| BECHTEL | Mechanical Handling Data Sheet<br>Top Running, Double Girder | **CM** △4 | Data Sheet No. 24590-HLW-M0D-HSH-00013 Rev. 4<br>Plant Item No. 24590-HLW-MJ-HSH-CRN-00001 |

| Project | RPP-WTP | Description | Melter 1 Cave Main Crane |

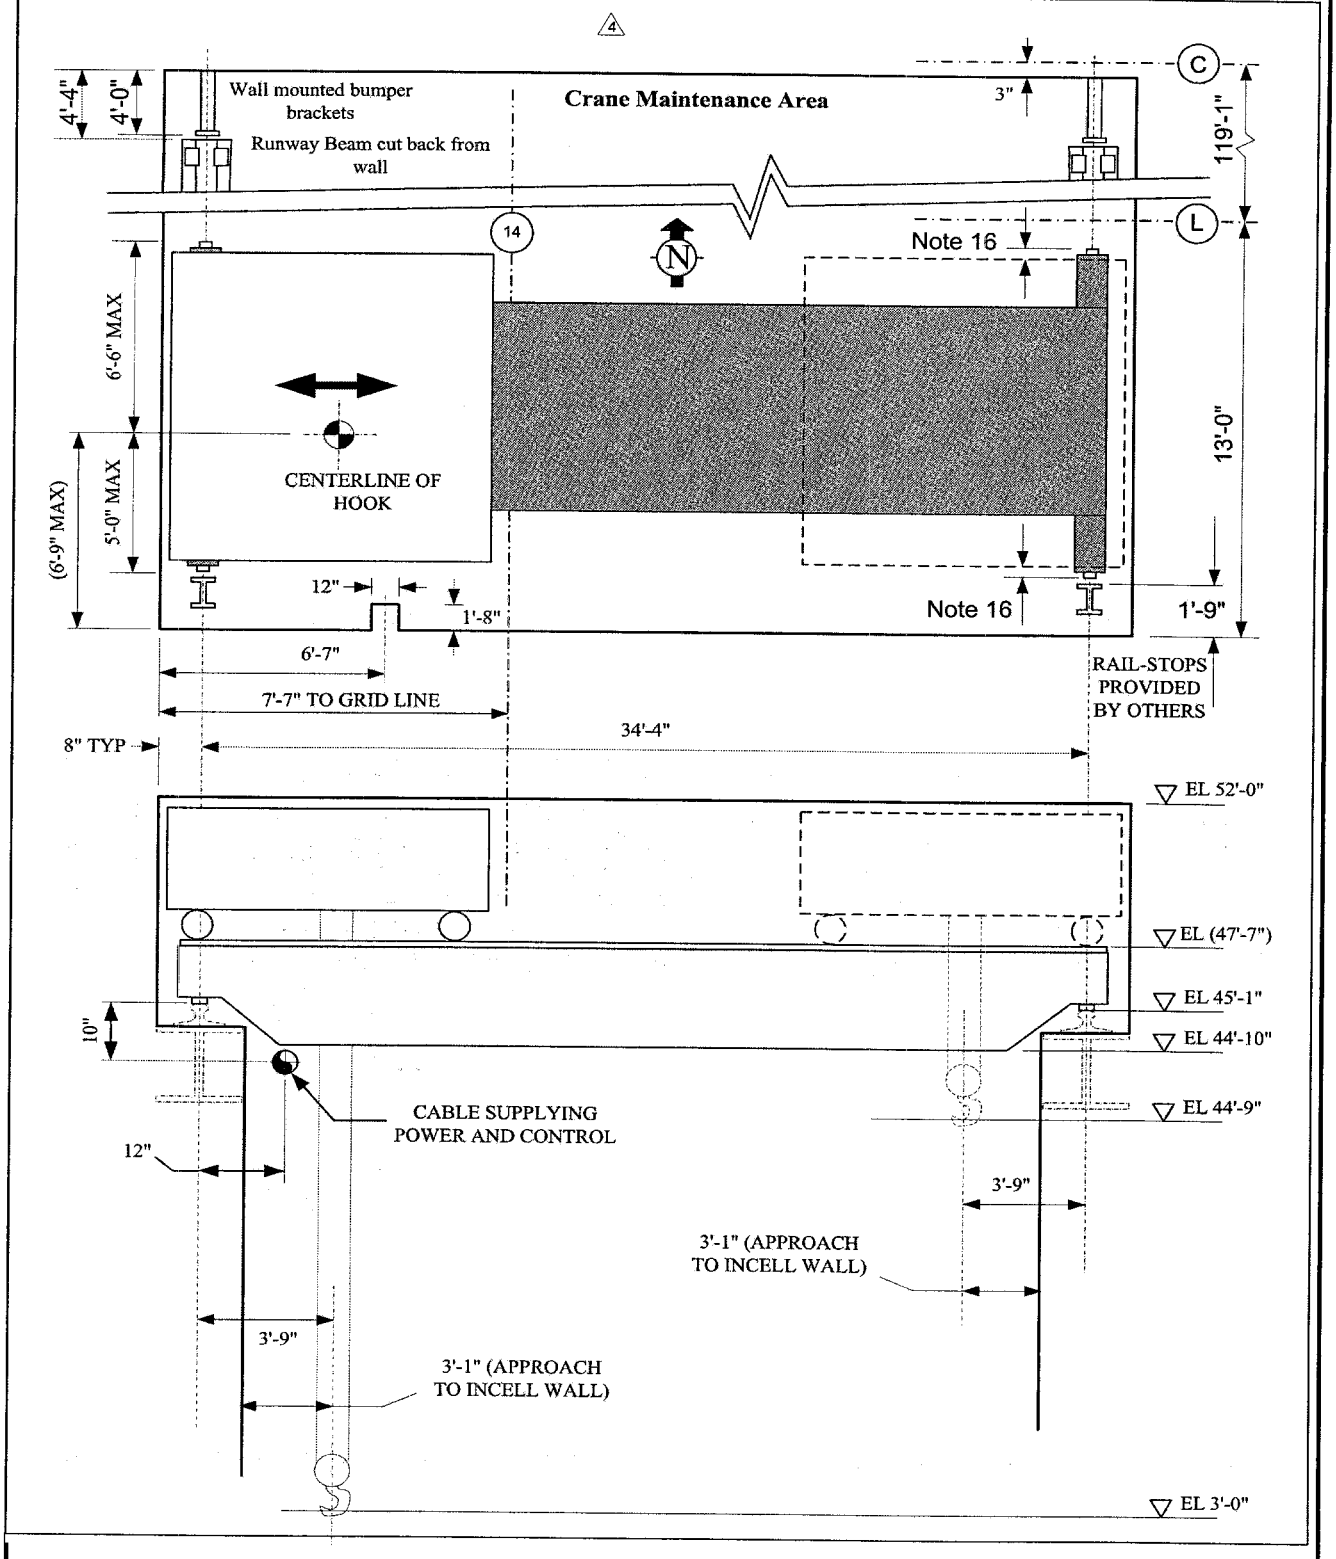
► 16. Trolley may not extend past fully compressed end truck bumper. 4

► 17. Revised sketch on page 3, changed Safety Classification from SDS to APC; Quality Level changed from QL to CM 4 and revised environmental conditions 4
